JONES et al.
Application No. 09/869,978
April 5, 2004

AMENDMENTS TO THE DRAWINGS

Figure 1

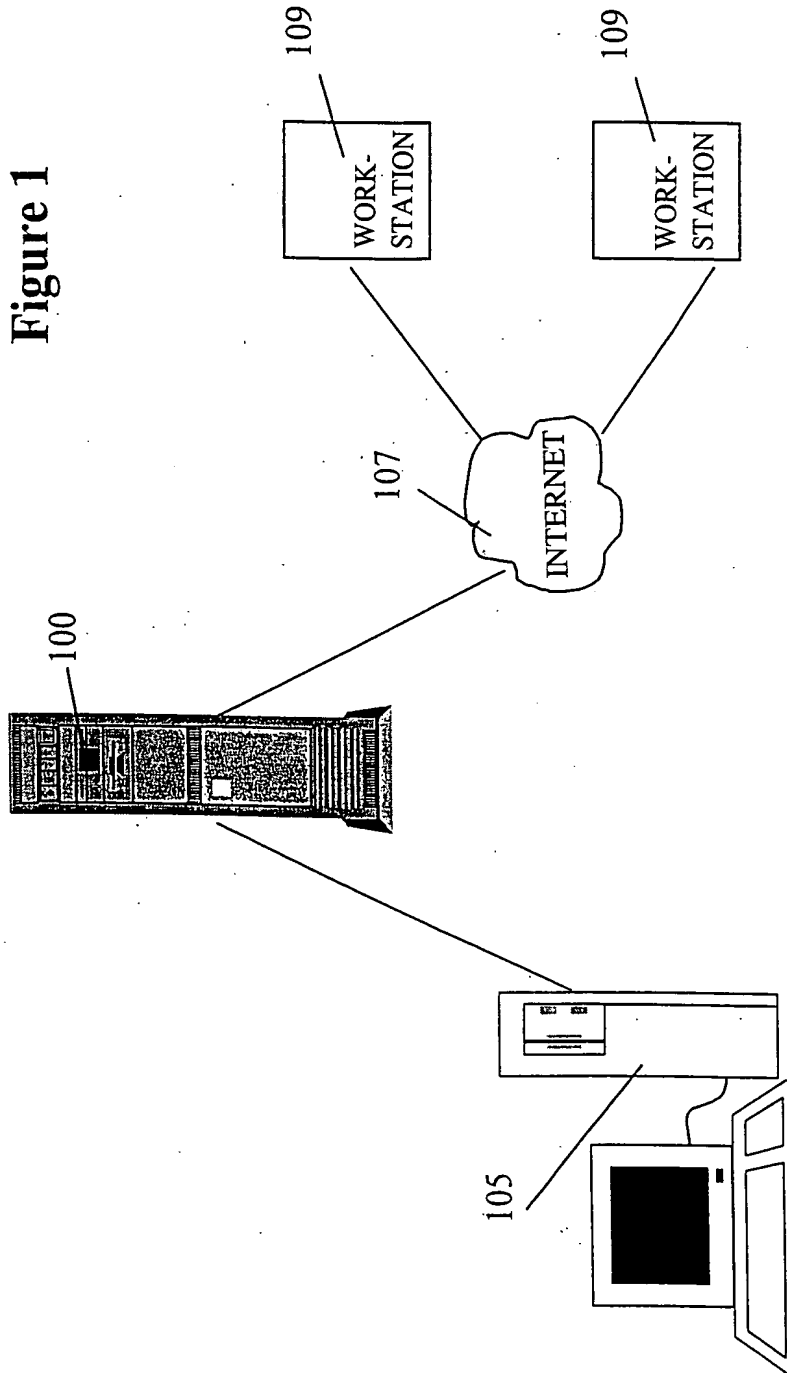
The attached sheets of drawings include changes to Figs. 1, 2 and 8. These sheets, which include Figs. 1, 2 and 8, replace the original sheets including Figs. 1, 2 and 8. In Figures 1 and 2, appropriate labels have been provided to various elements. In Fig. 8, reference numerals “907” and “909”, discussed on page 15, line 15 of the written specification have been included in Fig. 8.
